IDA PAPER P-3016

INDEPENDENT REVIEW OF THE DEVELOPMENT
RISKS ASSOCIATED WITH THE COMANCHE
ARMED RECONNAISSANCE HELICOPTER

August 1994

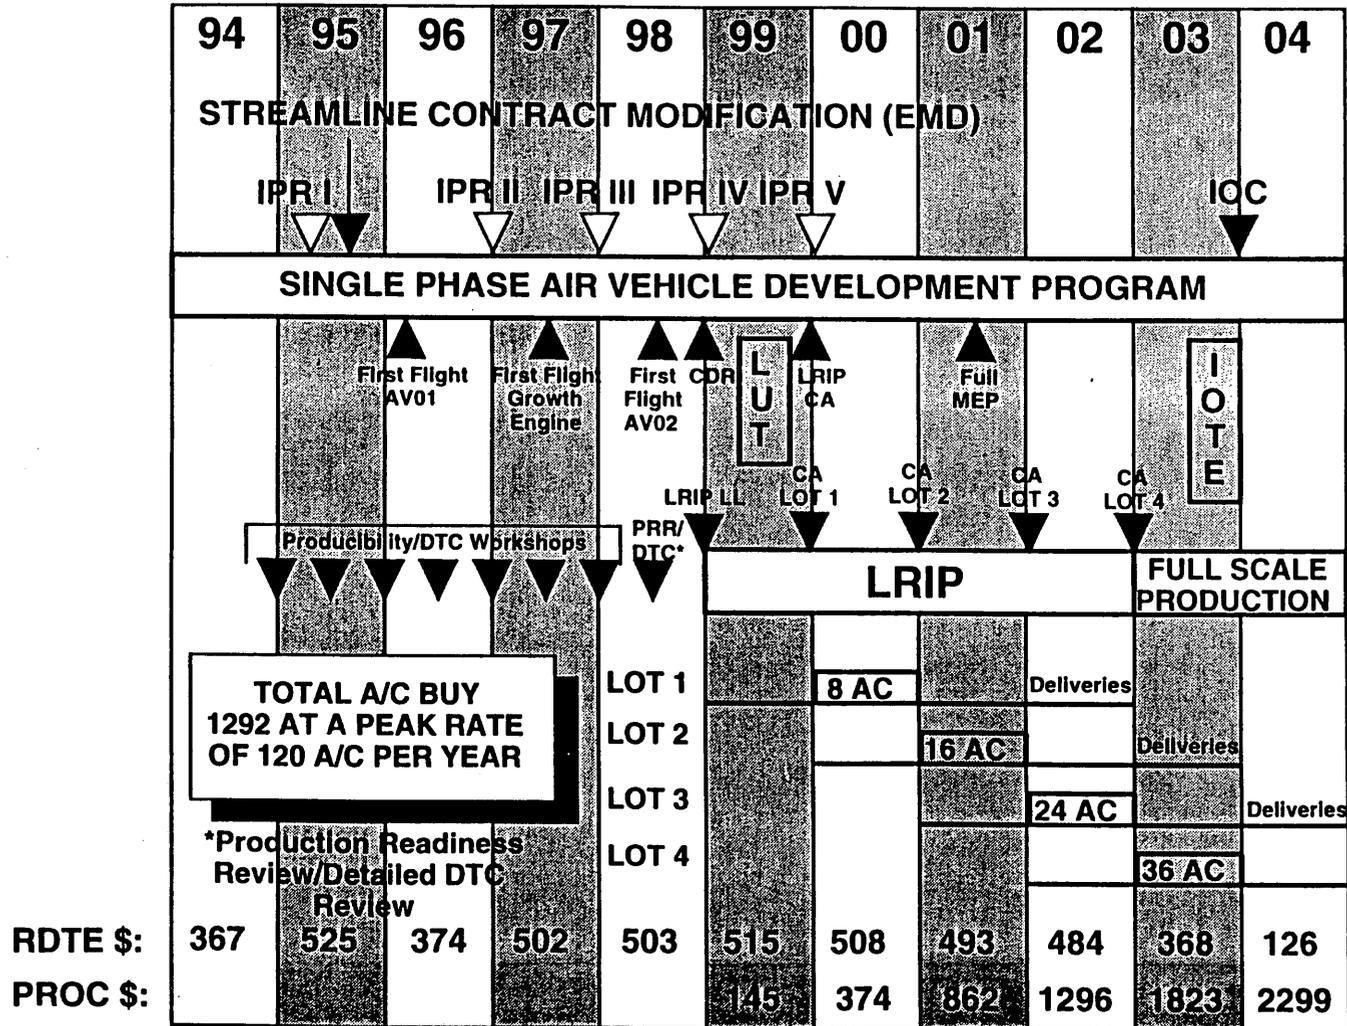
The schedule for the "streamlined" development program proposed by the Army is shown on this chart. Under this plan, in May 1995 the Army would modify the existing COMANCHE development contract to incorporate the activities normally conducted during EMD into a new single-phase development program. The first flight of the first of two DEM/VAL prototypes would occur in early FY 1996, several months later than was proposed under the existing development contract. The first flight of the second DEM/VAL prototype would not occur until late FY 1998, nearly 2 1/2 years after the first flight of the first prototype. The next three prototypes would be taken from the first lot of eight Low-Rate Initial Production (LRIP) aircraft. These prototypes would be delivered to the Army during FY 2002.

In comparison to the Army's previous plan for COMANCHE development, the "streamlined" plan initiates production one year earlier, but at a significantly slower rate. In the first year (FY 2000), only 8 aircraft would be built; in the second, 16 aircraft; in the third, 24 aircraft; and in the fourth (FY 2003), 36 aircraft.

OSD oversight for this program would be accomplished through a series of In-Process Reviews (IPRs), the first of which would occur early in FY 1995 prior to the award of the modified development contract. Beginning at the end of FY 1996, in-process reviews would

be scheduled annually to enable OSD to track program development.

Finally, as indicated on the chart, the funding profile for the proposed "streamlined" program is the same as that currently planned for the existing program.
